BART Warm Springs Extension Project

Final SEIR Addendum

Photovoltaic Panels

October 17, 2012

**FIGURE A
WARM SPRINGS EXTENSION
PROPOSED PV LOCATION PLAN**

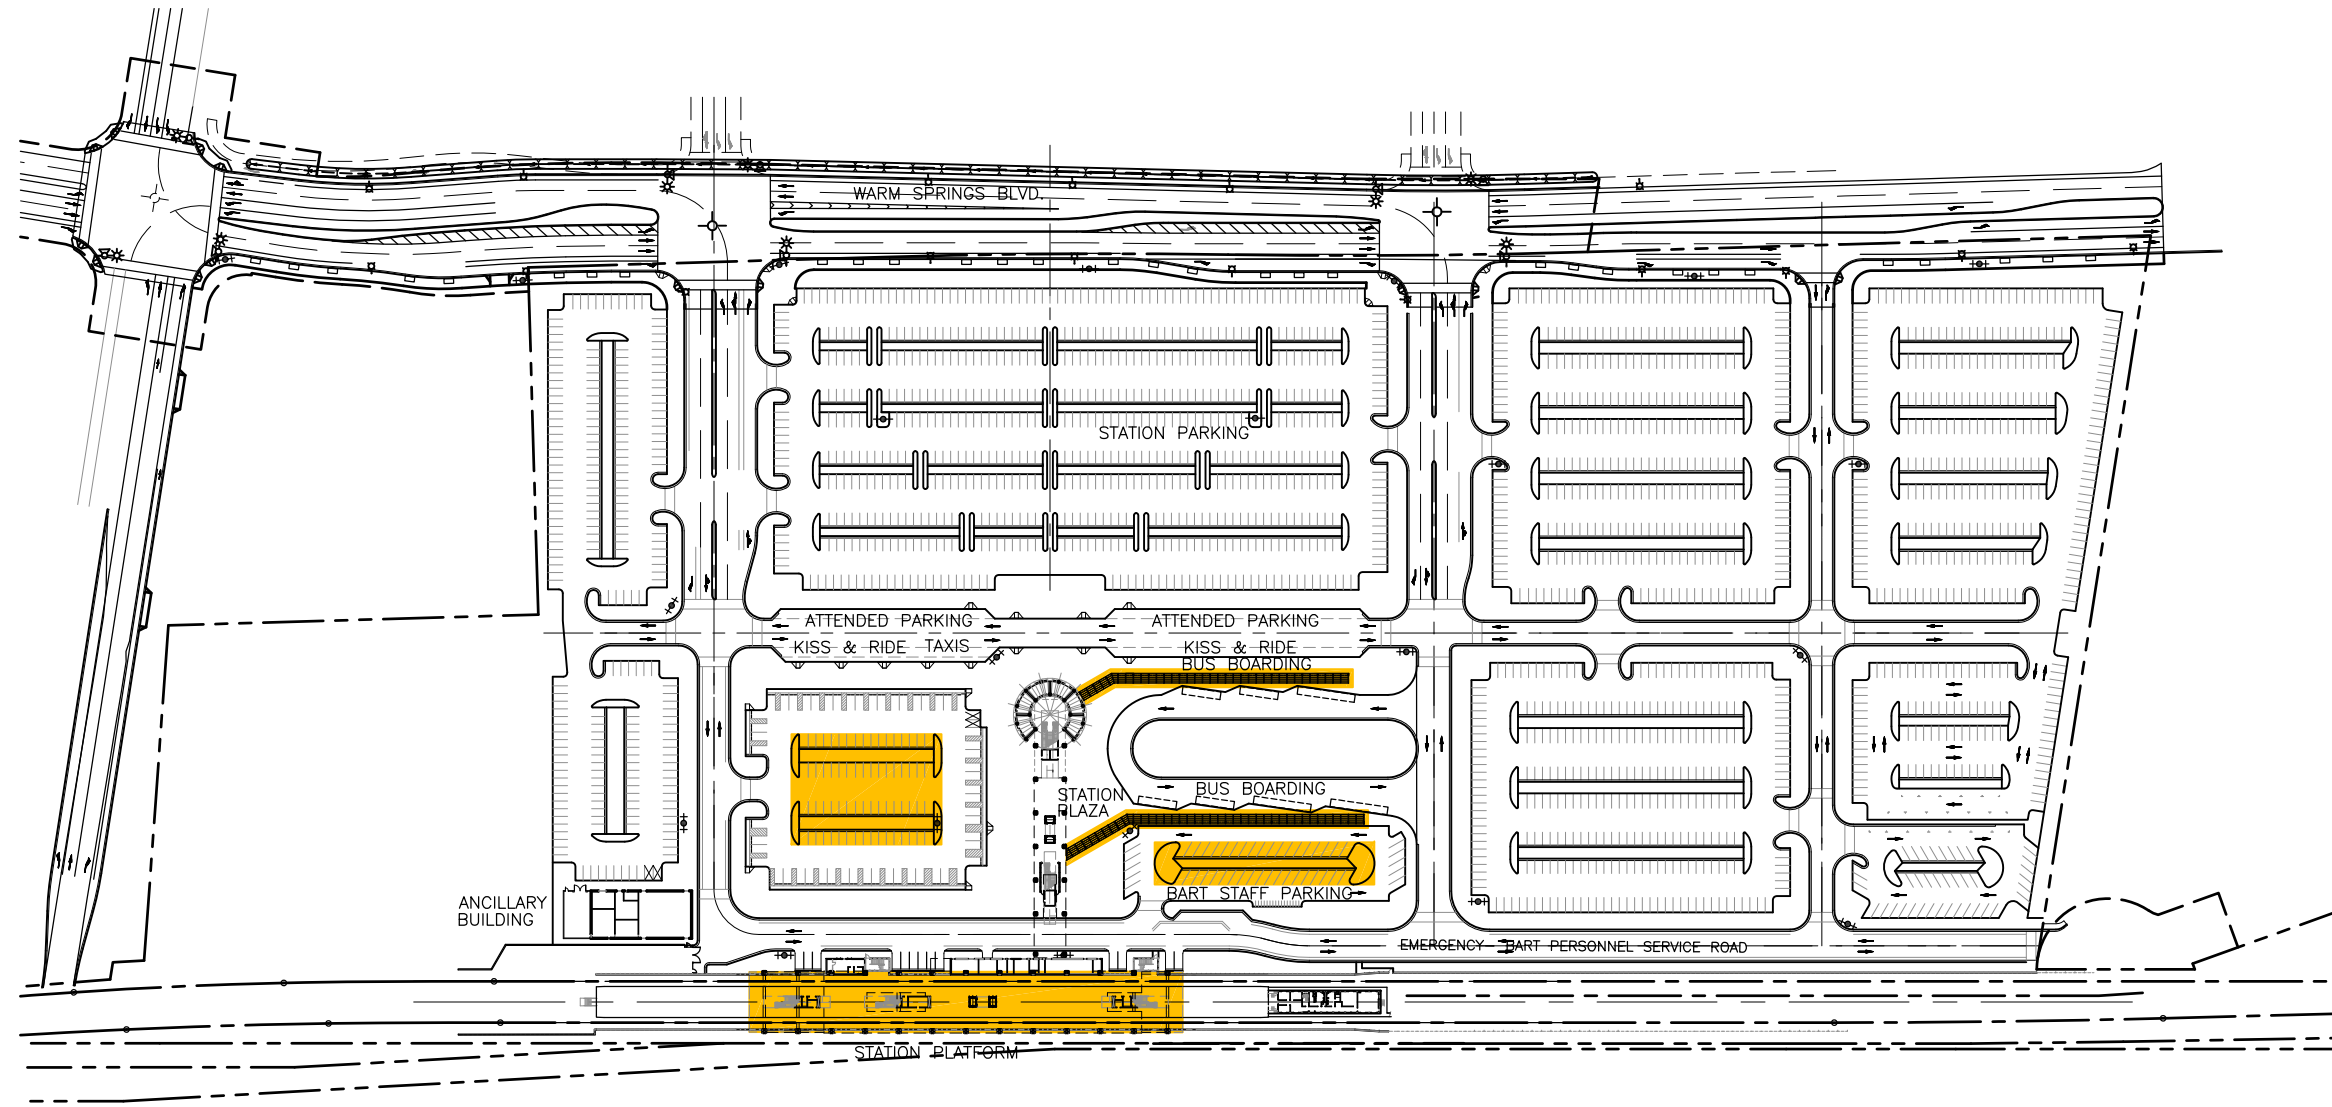
Warm Springs/South Fremont Station. PV locations at Warm Springs/South Fremont Station would include the station concourse rooftop, two bus boarding canopy rooftops, and parking lot canopies over

the 38 BART staff and 68 patron parking spaces. The station concourse and bus boarding canopy roof structures are already included in the project, and PV panels would lie flat on those rooftops. In addition, new purpose-built canopies would be constructed over the BART staff parking and patron parking spaces. The purpose-built canopy structures would be sloped to optimize exposure to the sun and maximize generating capacity. The canopy structures would be approximately 16 feet high at the highest point and slope down to a minimum of 10 feet. Power generated by PV panels at the station is expected to be approximately 0.62 MW.³ The energy generated by the PV systems is expected to serve all the daytime electrical power needs of the station. At times the generation will exceed the station load, and the excess will be fed back into the local electrical grid as it is generated. Figure B illustrates the location of the PV panels at the Warm Springs/South Fremont Station, and Figure C provides a simulation of the station with canopies and panels installed.

Subway Ventilation Structures. PV panels also would be added on the roofs of the two subway ventilation structures at Fremont Central Park. The two ventilation structures in the park are each approximately 208 feet long, 48 feet wide and 12 feet high. The panels would be entirely within the rooftop parapet wall of each ventilation structure and would cover approximately 50 percent of each rooftop's surface. The panels would be sloped to optimize exposure to the sun and maximize generating capacity. The PV panels on the two vent structures collectively would generate approximately 0.07 MW of power.⁴ Figure D presents a simulation of the PV panel atop the western ventilation structure in Fremont Central Park.
